Technical Service Bulletin

Subject: 07-005/17 - POOR AIR CONDITIONING PERFORMANCE AND OPERATION	Bulletin No.: 07-005/17
	Last Issued: 06/30/2017

2016-2017 CX-9 vehicles with VINs lower than **JM3TC*****142099** (produced before May 19, 2017)

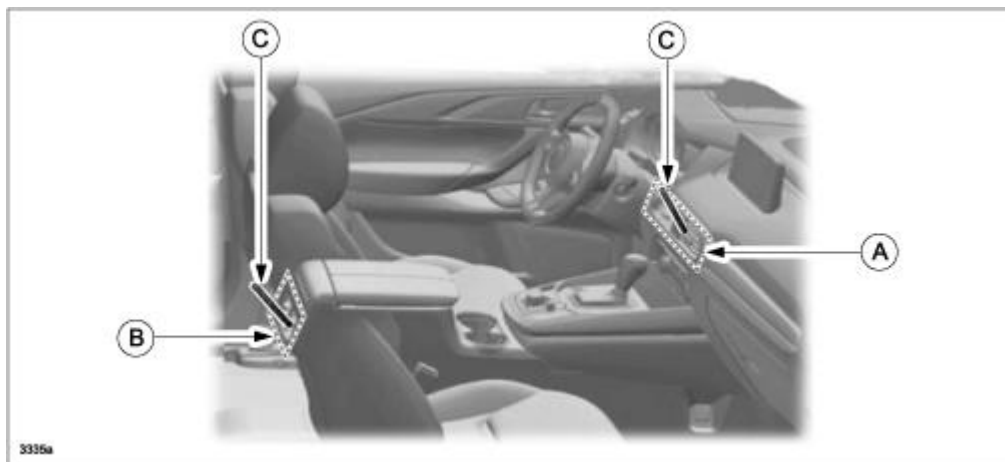
3. Measure the air conditioner output temperature from the passenger's side center ventilator (A) and rear ventilator (B) outlets according to the instructions on MGSS online (REFRIGERANT SYSTEM PERFORMANCE TEST). Record the output temperature values with a dry-bulb thermometer (C) and the ambient temperature when it is measured.

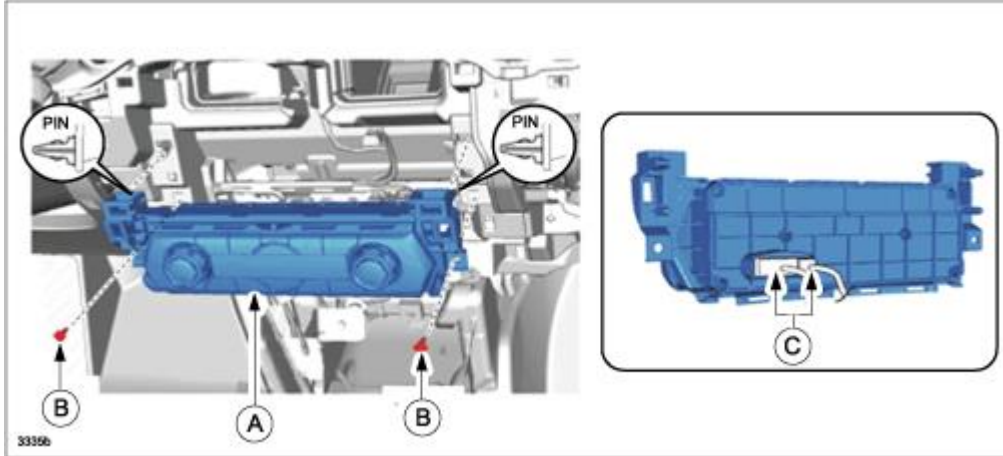
6. Replace the front climate control unit (A) with a modified one according to the instructions on MGSS online (FRONT CLIMATE CONTROL UNIT REMOVAL/INSTALLATION). Screws (B) and connector (C).

For 1) and 2), the front and rear climate control unit software has been modified to optimize the amount of air blown and the A/C compressor ON/OFF controls. For 3), the inner configuration of the side ventilation grilles has been changed to widen the adjustable range.

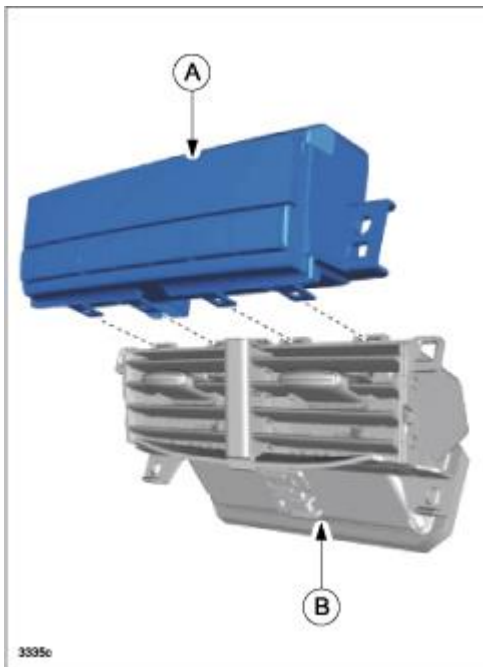
7.(FOR TYPE A VEHICLES ONLY) Replace the rear climate control unit (A) with a modified one according to the instructions on MGSS online (REAR CLIMATE CONTROL UNIT REMOVAL/INSTALLATION). Rear ventilator grille (B).

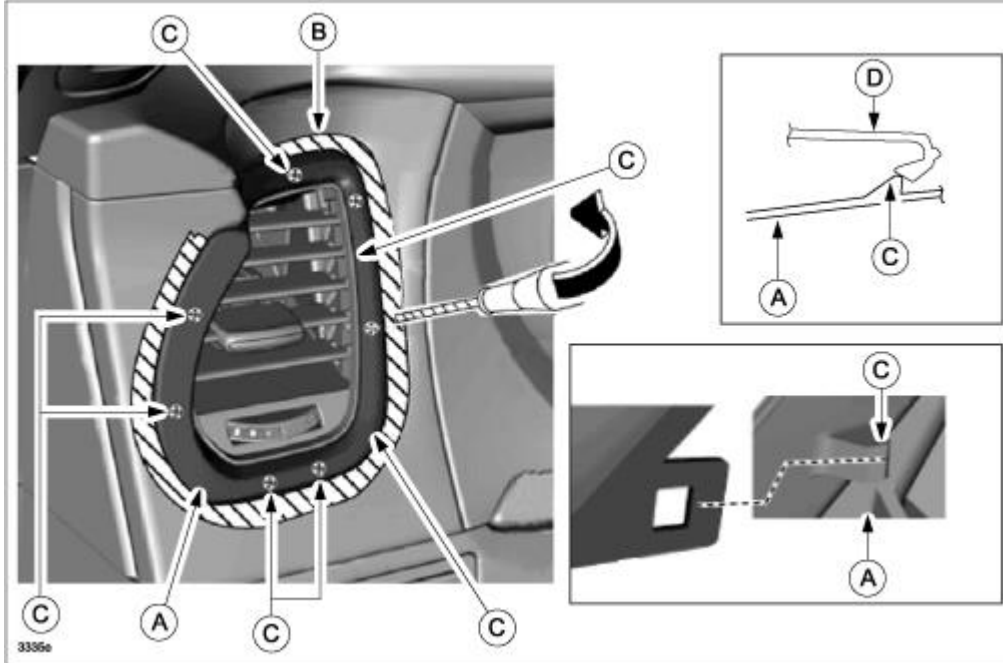
8.(FOR ALL VEHICLES TYPES) Replace the side ventilator grills (A) with modified ones according to the instructions on MGSS online (VENTILATOR GRILLE REMOVAL/INSTALLATION). B - Protective Tape, C - Tabs, D - Dashboard
